P&Z STAFF REPORT

Board of Appeals Hearing; Aug 14, 2018

Case: **V18-0017 – 7799 Roswell Road – Classic Karma of Atlanta**

DETAILED SITE PLAN-ROSWELL ROAD FRONTAGE

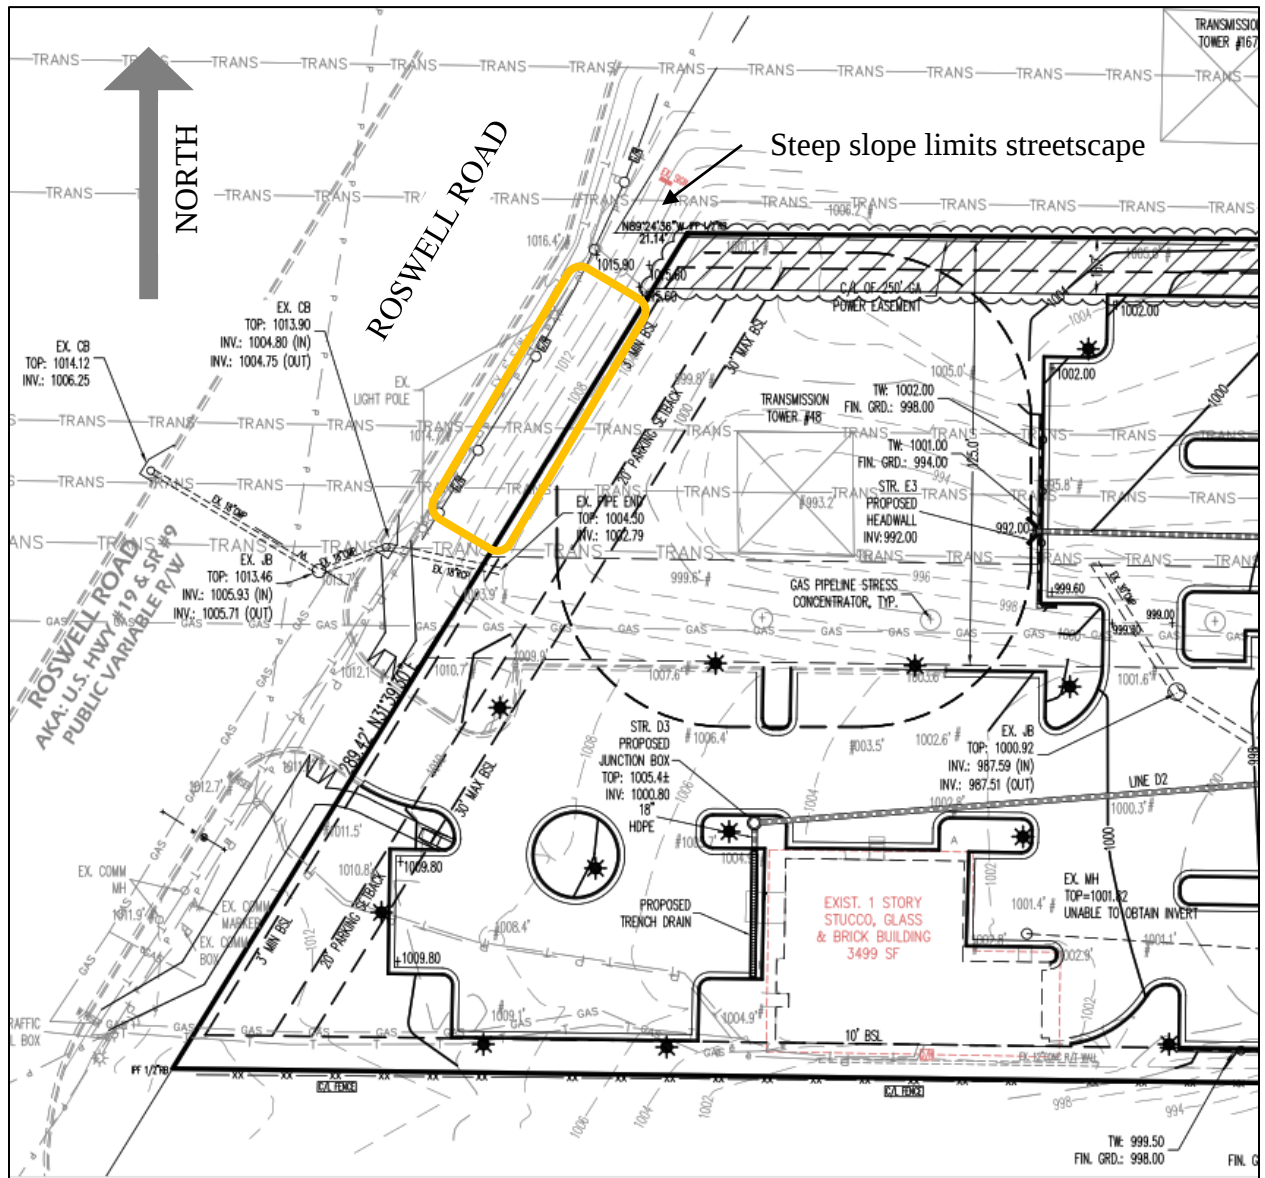
The applicant has requested a variance from Section 10.4.9 of the Development Code to modify the Roswell Road Streetscape Standards due to the steep bank between the back of the sidewalk and the property line and the location of the power transmission tower adjacent to the steep slope and Roswell Road ROW. The proposed site plan shows approximately 110 feet of streetscape left as it exists today with a 2' landscape strip behind the curb, 5' wide sidewalk, decorative streetlights, a guardrail, and a row of Crape Myrtle trees at the top of a steep slope on the northern half of the site frontage. A 10' landscape strip, 5' bicycle path, 9' sidewalk and 4' maintenance strip are proposed on the southern half of the site

1.a The application of this Development Code would create an unnecessary hardship, and not merely an inconvenience to the applicant. The subject property is encumbered with a number of easements and setbacks that limit development throughout the site. It is further encumbered by a steep bank along the Roswell Road ROW that creates a hardship to provide the Roswell Road Streetscape improvements. According to Section 10.4.9 of the Development Code a 10' minimum Street tree planting zone, 5' minimum bike facility, 9' minimum walkway, and 1' maintenance strip would be required adjacent to the curb. Grading the site to provide these streetscape improvements would push into the adjacent transmission tower and surrounding setbacks.

2.b The variance request would provide the minimum relief necessary to make possible the reasonable use of the property. Streetscape improvements were recently implemented along the frontage for the subject property. COSS Transportation comments state "Based on Site topography along the Roswell Road Frontage, support for streetscape reduction to provide 2 feet grass strip and 6 foot sidewalk is reasonable."

1. Based on Site topography along the Roswell Road Frontage, support for streetscape reduction to provide 2 feet grass strip and 6 foot sidewalk is reasonable.
2. Landscape Islands should remain within the Transmission Line Easement. Planting of trees should be in accordance with Georgia Power's list which does not allow canopy type trees or waived.
3. If Applicant is seeking to eliminate landscape islands over the Gas Pipeline, they should:
 - A. Obtain a letter from the Pipeline owner expressing support for not installing curbed islands in these areas.
 - B. Provide depth measurements as taken by the Pipeline showing depth of pipes that are causing the conflict to support this request.
4. Amenity area - no comment.

Staff finds that granting a modification in the Roswell Road Streetscape Standards would not be detrimental to the public good, safety and welfare but recommends the condition that the Roswell Road streetscape standards be implemented where the grade allows on the southern half of the site as shown on the site plan received by COSS on August 2, 2018.

DETAILED SITE PLAN-PARKING ISLANDS OVER COLONIAL PIPELINE EASEMENT

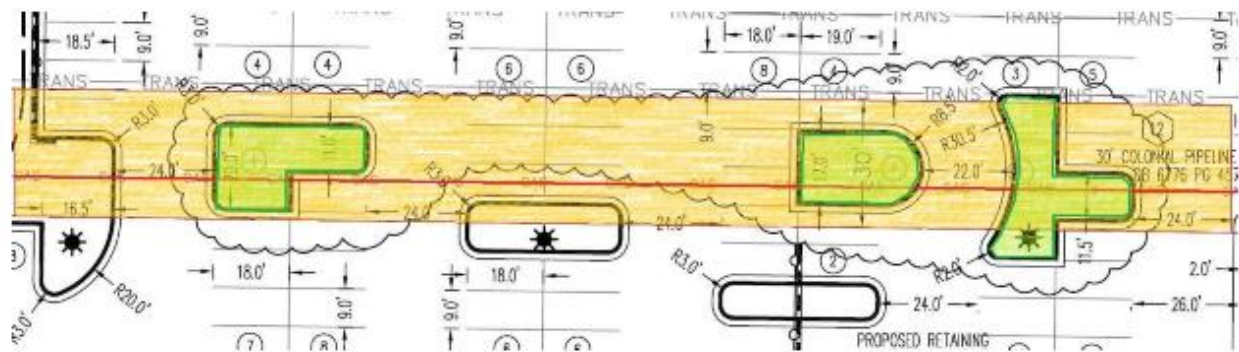
The applicant has requested a variance from Section 8.2.2.C of the Development Code to eliminate shade trees in three (3) interior parking islands that are within the Colonial Pipeline Company's gas easement and constrained by the encroachment agreement planting limitations that prohibit shade tree planting within their ROW. The Development Code requires 5 shade trees in the three parking islands within the Colonial Pipeline Company's gas easement.

2.b The variance request would provide the minimum relief necessary to make possible the reasonable use of the property. Relief of shade tree planting in these three (3) interior islands is needed to conform to the easement overlay conditions. This is the minimum relief necessary. Staff wondered if the applicant could have located the parking islands in a different configuration outside the Colonial Pipeline Company's gas easement but it appears there are Gas Pipeline Stress Concentrators above grade that force the location of parking islands around them.

Staff finds that granting a variance from Section 8.2.2.C of the Development Code to eliminate shade trees in three (3) interior parking islands that are within the Colonial Pipeline Company's gas easement would not be detrimental to the public good, safety and welfare but recommends the condition that the five (5) shade trees required in the three (3) islands be planted in another location on the site.
